Technical Service Bulletin

57 Door cannot be opened from outside, it can only be opened from inside

57 14 99 2029151/5 January 3, 2014. Supersedes Technical Service Bulletin Group 57 number 13-87 dated March 27, 2013 for reasons listed below.

Figure 4. Holding the yellow sleeve in the lock.

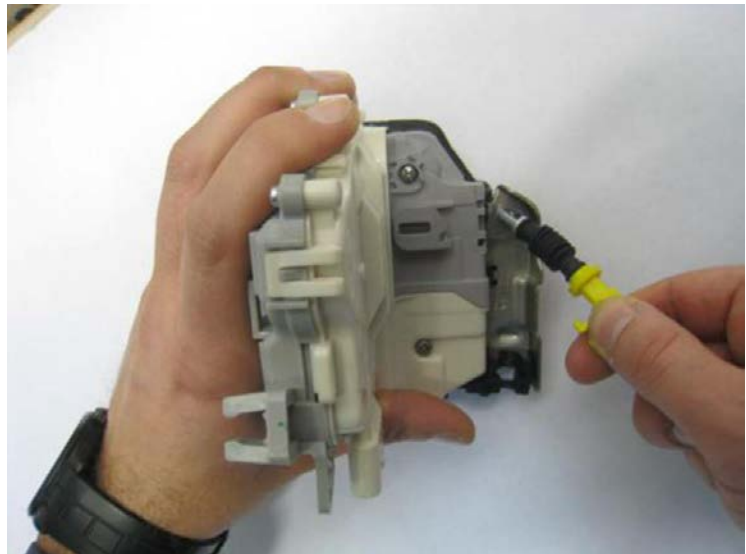
- a. Position the Bowden cable by holding the yellow sleeve in the lock (Figure 4).
